Watts Bar Nuclear Plant, Unit 1  
Facility Operating License Nos. NFP-90  
NRC Docket No. 50-390

Subject: **Application to Revise Technical Specification 4.2.1, "Fuel Assemblies" (WBN-TS-15-03) (TAC No. MF6050) - Response to NRC Request for Additional Information - Reactor Systems Branch**

#### TVA Response to NRC Request for Additional Information

Schematic of the Pellet Leaching Test Configuration

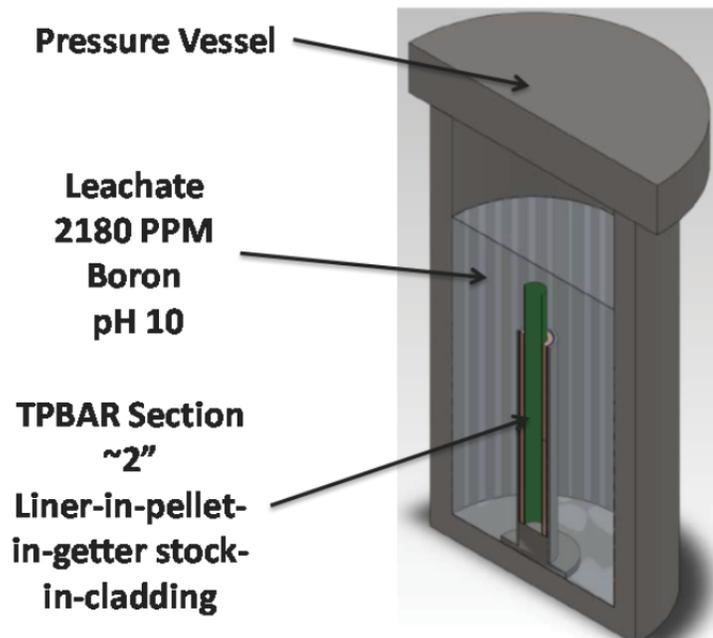
- a. A description of the test conditions, including ambient fluid conditions, fluid flow, installation configuration for the TPBAR, and mechanical loads.

The tested configuration consisted of a sample TPBAR section in a pressure vessel as shown in the figure below. Each sample TPBAR section was fabricated with uncoated cladding and getter stock, production inner material, and two irradiated lithium aluminate pellets ( $\text{LiAlO}_2$ ). A buffered, pH-adjusted borated test solution (2180 ppm boron and pH of 10) was used to simulate the sump water. The test solution was periodically sampled and replaced with fresh solution.

The leach tests were performed in unstirred stainless steel pressure vessels at 120°C and as-generated pressures. An actual TPBAR cladding breach creates a tortuous path that does not allow for free flowing coolant interaction with the pellet material. Therefore, no continuous flow past the TPBAR sections was used in the leach testing. Leaching of  $\text{LiAlO}_2$  within a breached TPBAR occurs in stagnant conditions within the TPBAR. However, to conservatively bound the breach configuration relative to coolant interaction with the pellets, an open ended cladding section was used in the pellet leach test. The test included the mechanical loads due to temperature effects, thermal expansion and pressure. The test was conducted at bounding post-LOCA temperature and pressure conditions.
